PACIFIC GAS AND ELECTRIC COMPANY

Re: Docket No. 50-275, OL-DPR-80
 Diablo Canyon Unit 1
 Spent Fuel Storage Racks

EVALUATION OF
REINSTALLATION OF
ORIGINAL SPENT FUEL RACKS
DIABLO CANYON POWER PLANT UNIT 1

AMENDMENT 2

SECTION THROUGH ANCHORAGE

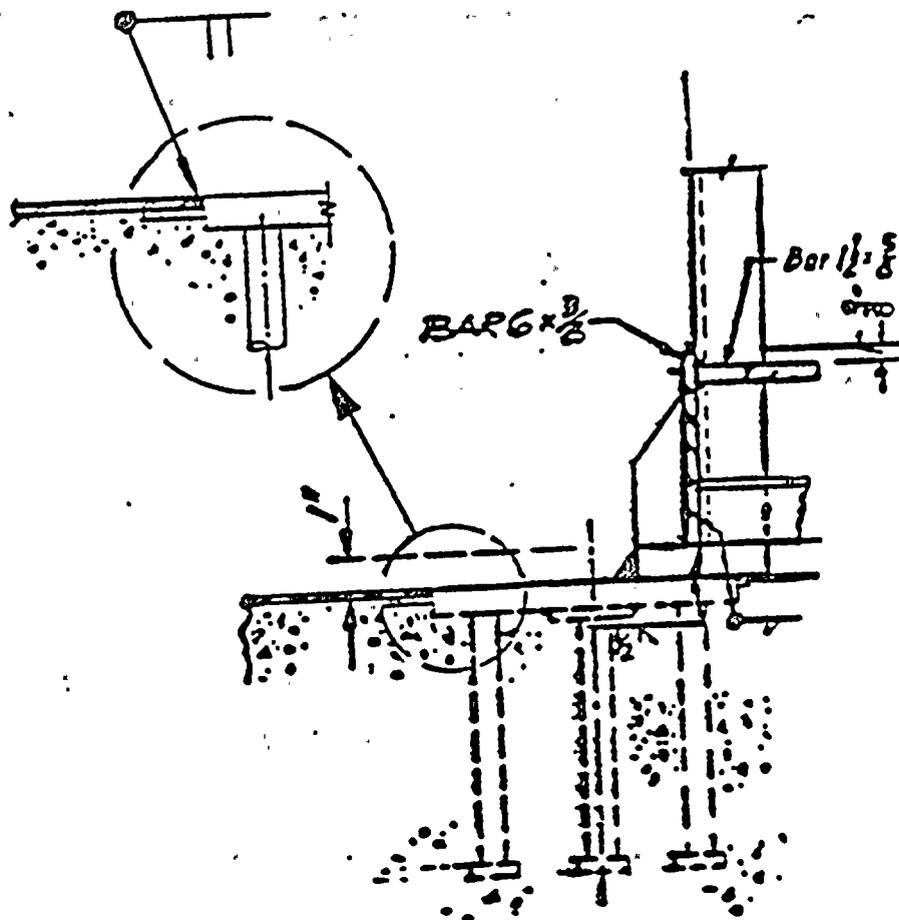
- A. The racks were attached to the plate embedded in the bottom of the spent fuel pool by bolts which were fillet welded to the embedded plate. All forces were transferred to the embed through these fillet welds (Figure 18). Refer to Figures 8 and 9 for details of the revised welded connections.
- B. In lieu of adding weld metal to increase the strength of the connection of diagonal bracing, a 2" x 1-1/4" x 16" bar was welded to the bracing. Refer to Figure 10 for the details of this bar and its attachment to the bracing.
- C. Weld material was added at one gusset plate location on Rack 8 to restore the rack to the original design. Refer to Figure 11 for details.
- D. One cell lacing bar was added on Rack No. 1 to repair damage which occurred during removal of the rack. Refer to Figure 12 for details.

- A. The racks were anchored using welded connections instead of bolted connections because of the increased seismic loading resulting from using the more conservative model used to determine rack stiffness (described in Section 4.3). To facilitate installation of the welded connection, all remaining bolts were ground off, and the embed cavity around each bolt was filled with weld metal and ground flush to achieve an uniform bearing surface (Refer to Figure 9). The load paths due to the revised configuration of the anchorage were evaluated and the results of this evaluation are as follows:

RACK ANCHORAGE

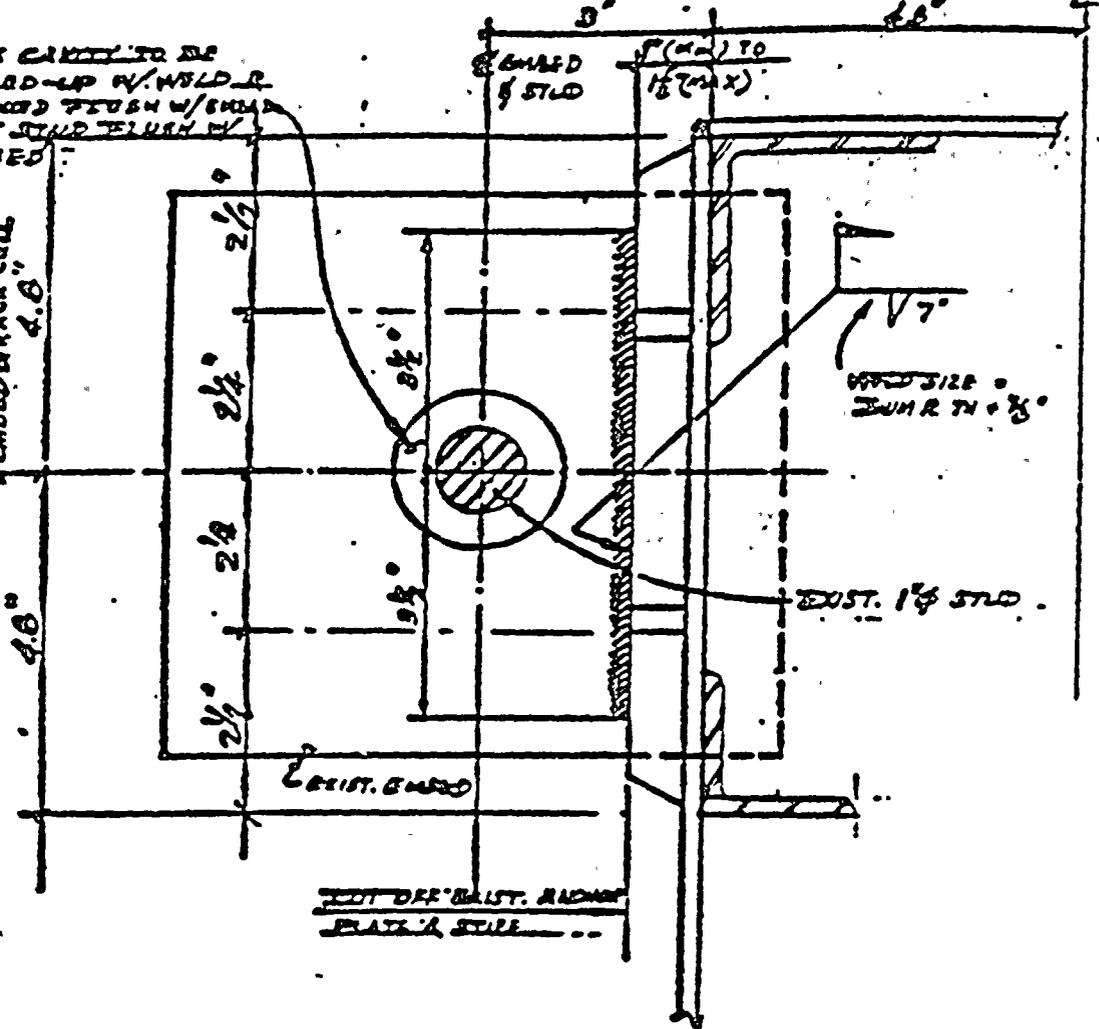
Anchor bolt bearing plates (anchor brackets), located at the corners of each rack, are welded to embedded plates to anchor the racks to the spent fuel pool floor. Changes to the anchor brackets were made to facilitate the welded design (see Figure 9). The embedded plates are attached to the spent fuel pool reinforced concrete using welded, headed studs.

REINFORCEMENT OF BRACING CONNECTION

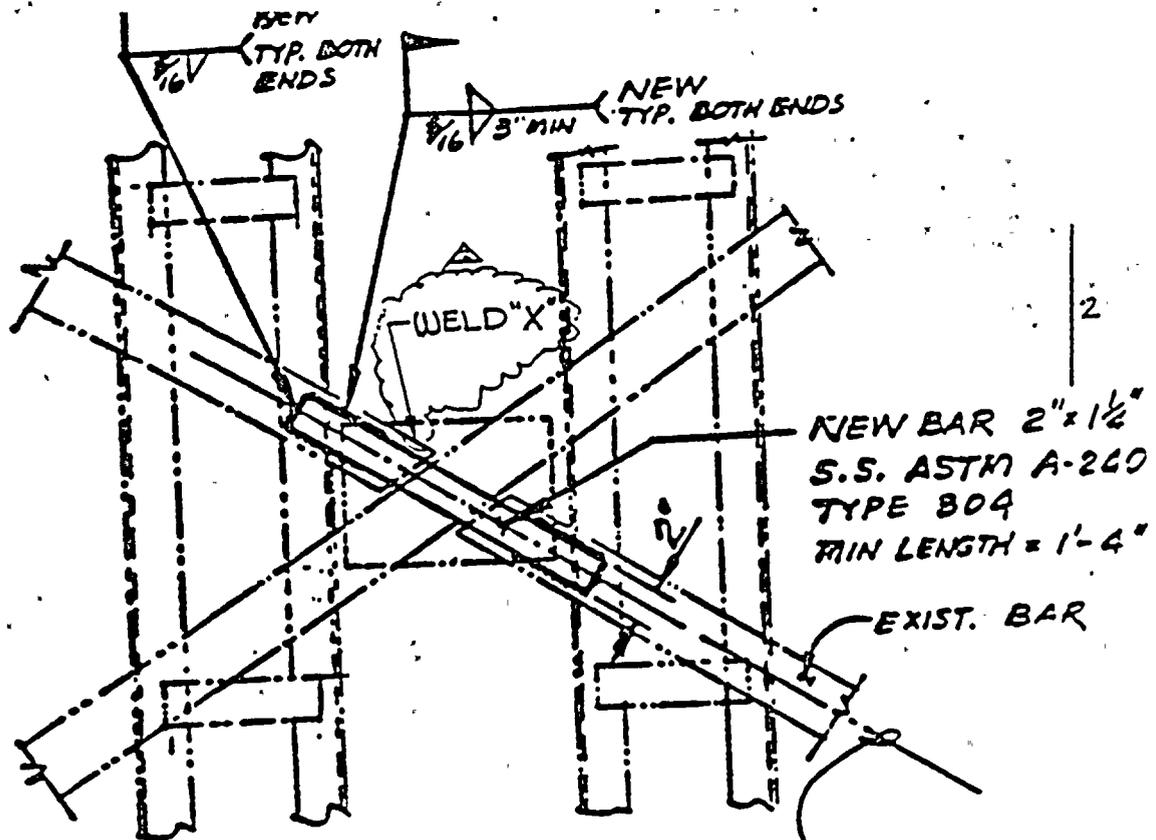
- B. The intersecting connection of the diagonal cross-bracing was reinforced by adding a welded connecting bar (Refer to Figure 10). The change resulted from an as-built review which found that a portion of the weld on the diagonal bracing intersection required by design was not adequate. A calculation was performed to demonstrate that the as-installed welds met acceptance criteria based on loads determined by the original calculation but not the new more conservative calculation. This bar was installed to provide the strength equivalent to that provided in the original design. This change was chosen for ease of construction and to minimize potential for distortion.

1. The diagonal to gusset plate weld identified as "X" in Figure 10 for Rack No. 2. Since the calculations for the connection conservatively neglected the strength contribution of this weld, the connection capacity remains unchanged.
2. The midheight gusset plate weld to corner cell angle for Rack No. 5. This weld is identified as "X" in Figure 3. This connection weld continues to have very large margin.
3. The welds connecting the lower diagonal brace to the gusset plate at the bottom left corner of Rack No. 6. This weld is identified as "X" in Figure 11. Since a more limiting dimension for this weld was used for analysis purposes, this connection continues to have ample margin.

REINFORCEMENT OF BRACING FOR RACK NO. B

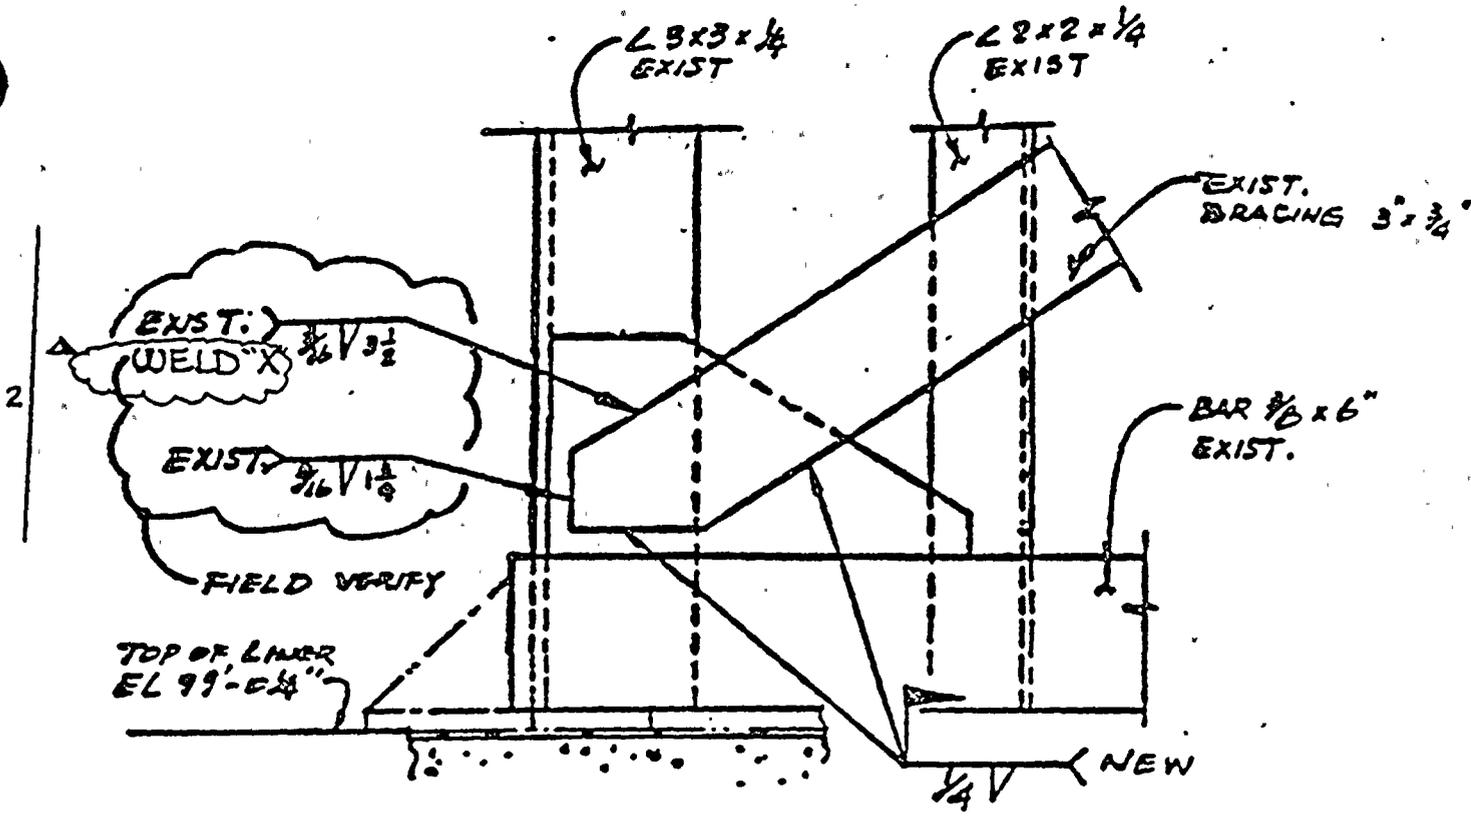
- C. An additional weld was specified at one gusset plate on Rack No. 8 (Refer to Figure 11) for reasons similar to the discussion in Paragraph B. The as-built review found that a portion of the weld required by design had not been provided. A calculation was performed to demonstrate that the as-installed weld met acceptance criteria based on loads generated by the original calculation but not the new more conservative calculation.

LACING MODIFICATION FOR RACK NO. 1

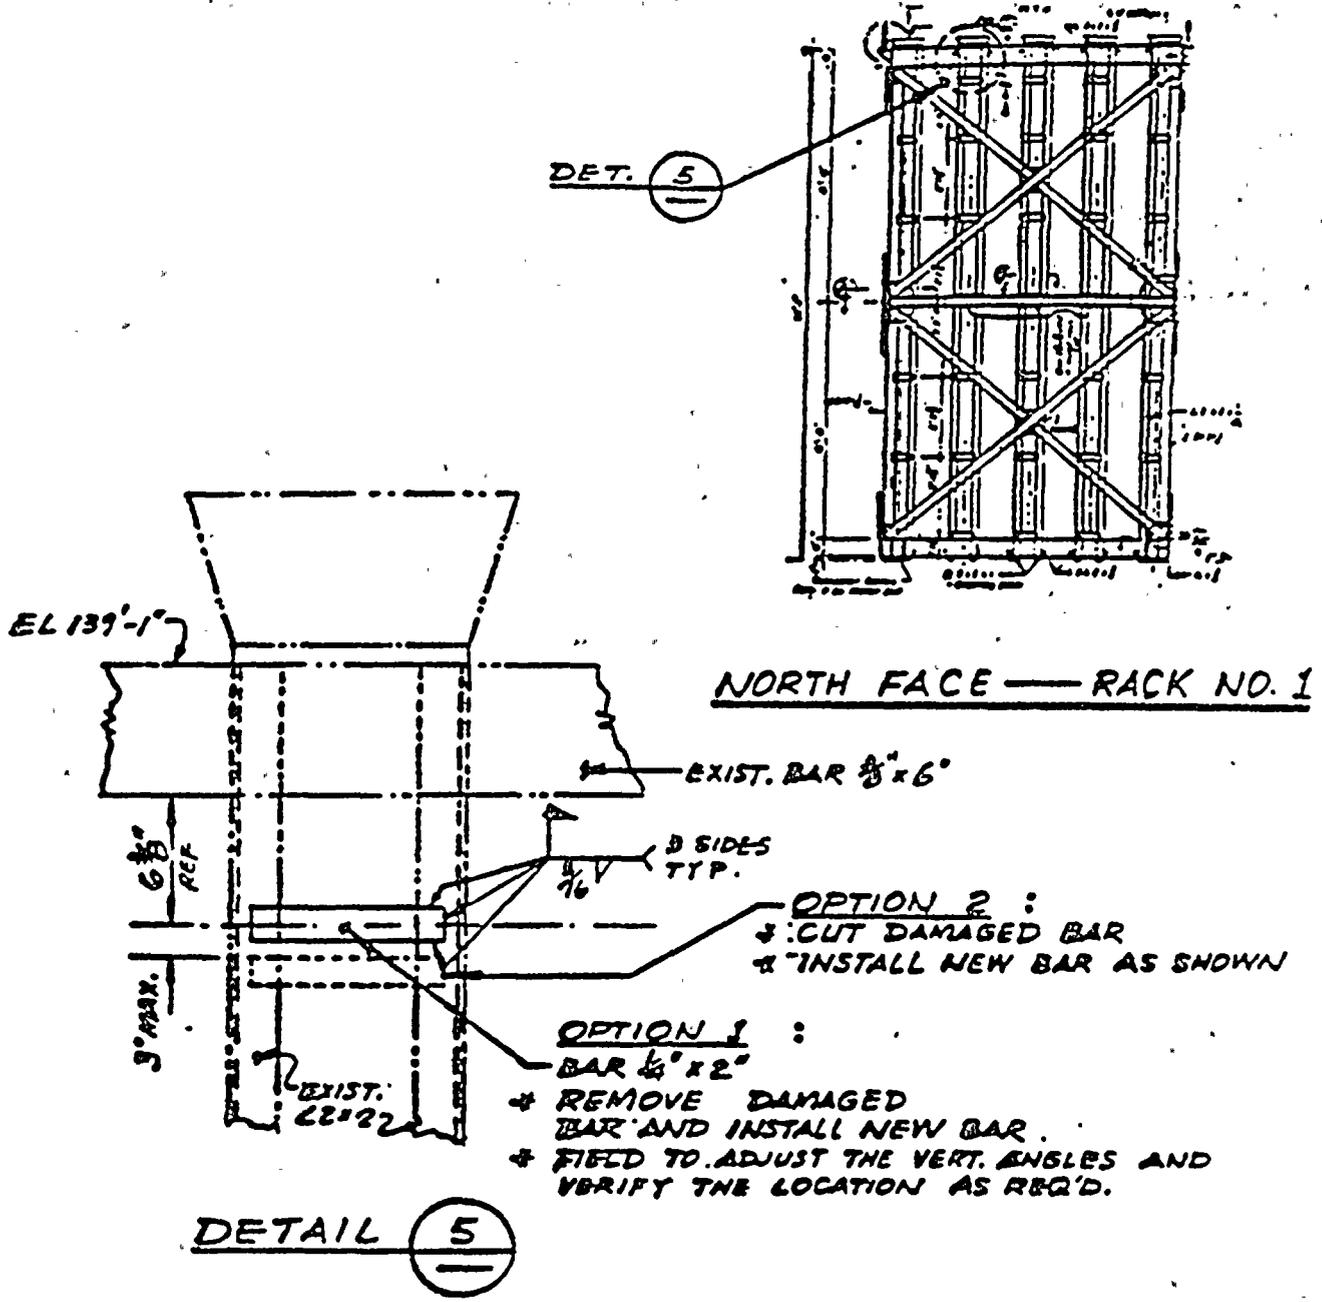
- D. One cell lacing bar was added to Rack No. 1 to repair damage to a lacing bar which was damaged during removal of the racks (Refer to Figure 12). The effects of the revised location of the lacing bar on the cell (local buckling) have been evaluated and found to be acceptable as indicated in Table 1.
